Channel Stability Problems, Pajaro River, Watsonville and Pajaro, California

**U.S. Army Engineer Committee on Channel
Stabilization Report of the 63rd Meeting**

ERDC/CHL SR-00-3
CCS-00-1
August 2000

Figure 5. Location map

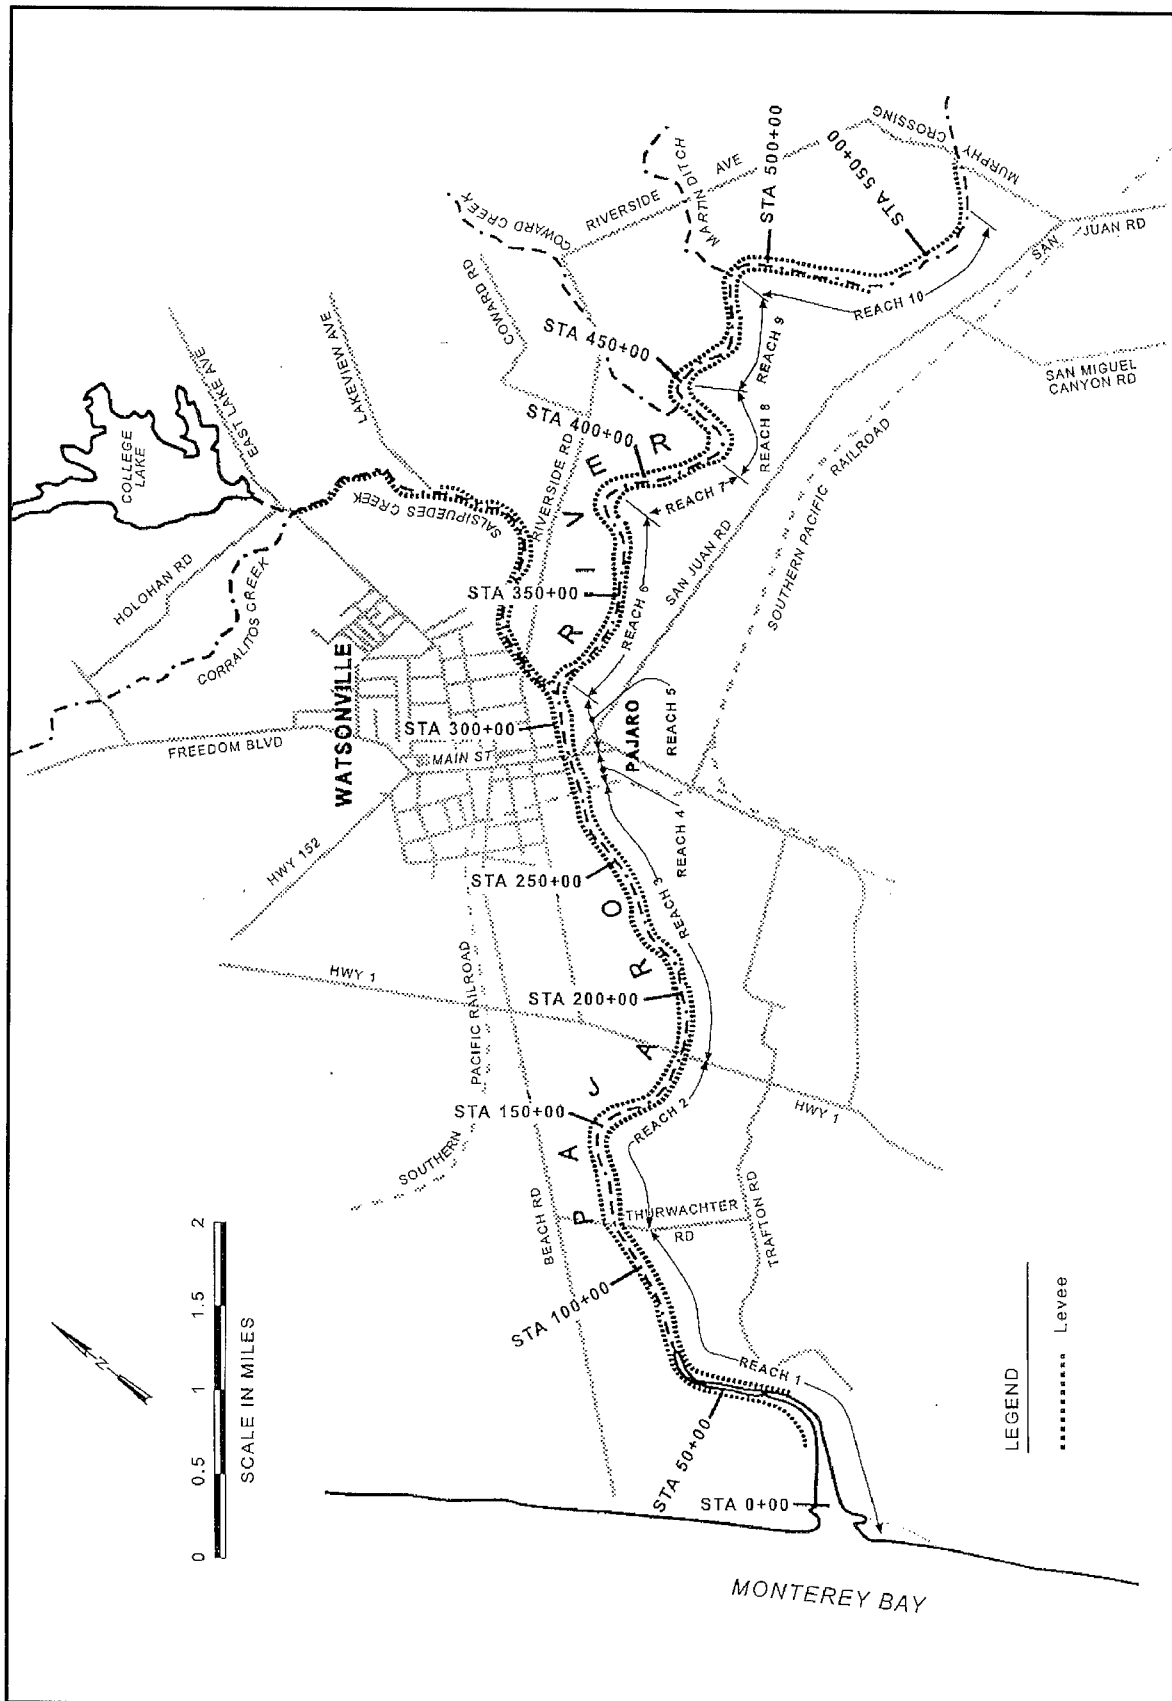
- a. Based upon the information provided in the pre-inspection briefing and field observations, it would appear that the high banks have eroded past the “original” high bank in a relatively few locations. (Figure 5) these are: (1) Sta 132+00 to 142+00 RB; (2) Sta 164+00 to 166+00 LB; (3) Sta 176+00 to 178+00 LB; (4) Sta 219+00 to 224+00 RB; (5) Sta 243+00 to 247+00 LB; (6) Sta 275+00 to 276+00 LB; (7) Sta 296+00 to 297+00 LB; (8) Sta 323+00 to 324+00 LB; (9) Sta 333+00 to 345+00 LB; (10) Sta 374+00 to 376+00 RB; (11) Sta 415+00 to 417+00 LB; (12) Sta 422+00 to 423+00 LB.

Figure 6. Incorrect installation of erosion control mats

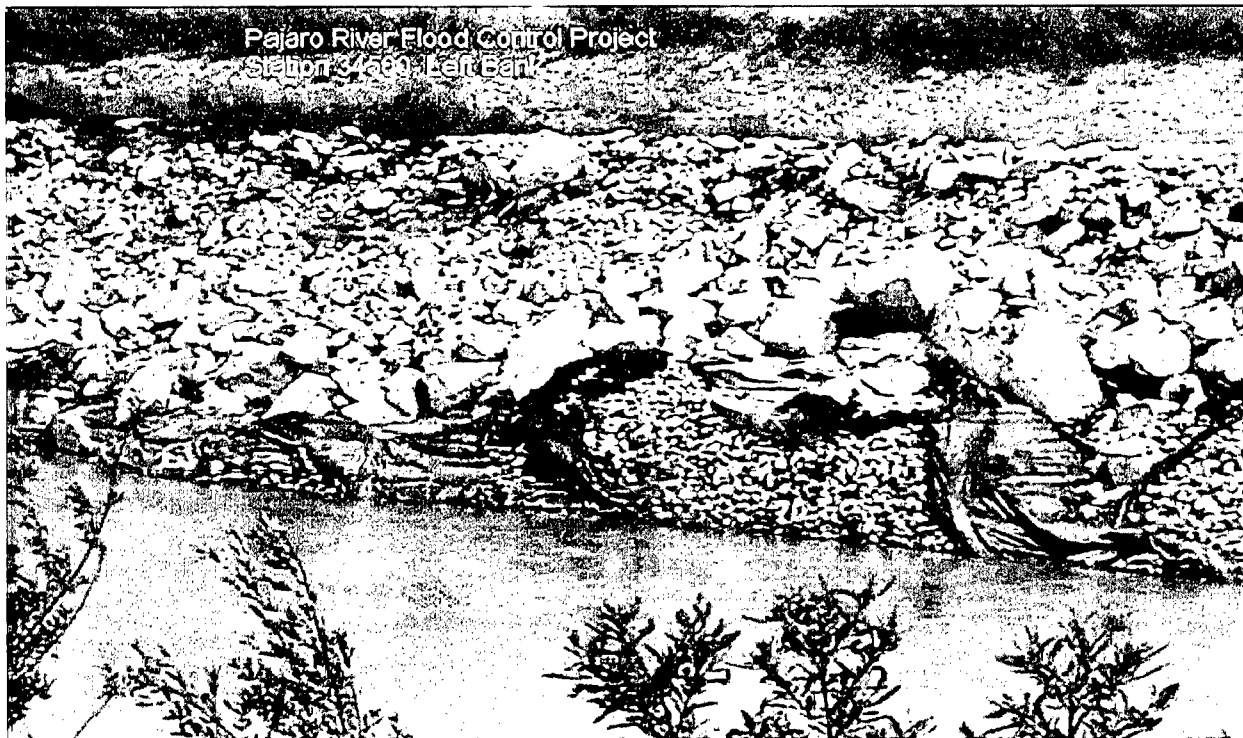
- c. The locations where the banks have been stabilized are very steep. Also, the stone, although apparently well graded, is inconsistent in size. The erosion control mats have been installed incorrectly and/or have been applied to situations for which they were not intended (see Figure 6).

Figure 7. Alternative 1a

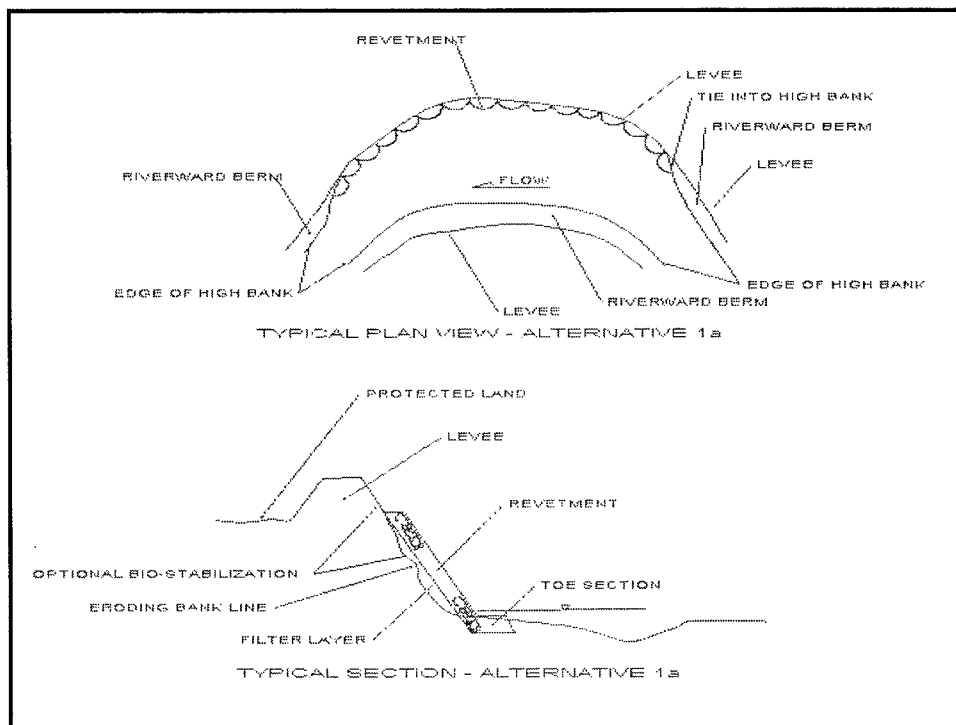
The Committee looked at two different scenarios for bank stabilization: first, where the bank has eroded up to the toe of the levee (within 10 ft); and second, where the bank has eroded to within 30 ft of the levee toe. For the first case the Committee developed three alternatives for stabilizing the banks (Figures 7 and 8). Alternatives for the second case are shown in Figure 9.

Figure 8. Alternative 1b and 1c

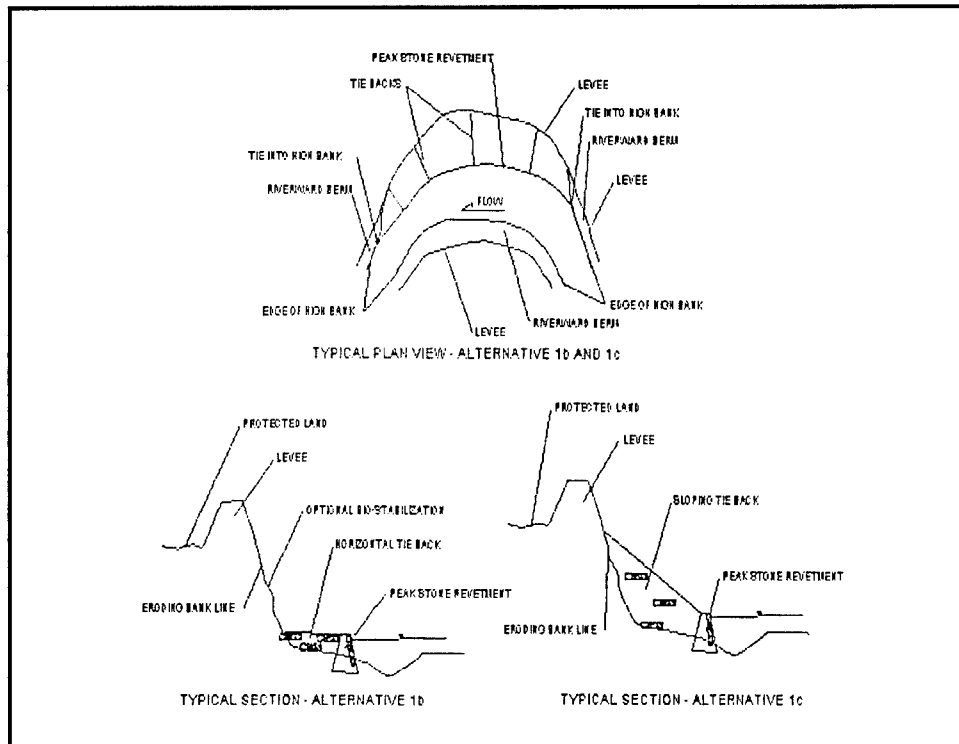
- a. Of the alternatives for stabilizing the banks that have eroded to the toe of the levee, Alternative 1b (peak stone revetment with horizontal tie backs) is my recommended plan. This alternative will provide protection for the toe of the bank without promoting excessive deposition. However, there are risks associated with leaving a vertical bank adjacent to a levee. These risks included subsequent geotechnical failures, continued erosion during prolonged high-flow events, and decreased seepage paths. To counter some of these impacts, biostabilization could be employed above the horizontal tiebacks, or every second or third tieback could be a sloping tieback. The tiebacks should be perpendicular to the peak stone revetment, and should be spaced at 100-250-ft intervals depending on the degree of curvature in the bend. The tighter the bend the closer the spacing.

The peak stone revetment and tiebacks are shown in the figures as being constructed of stone, and this is the preferred method due to long-term reliability. However, the structures could be constructed of woven wire
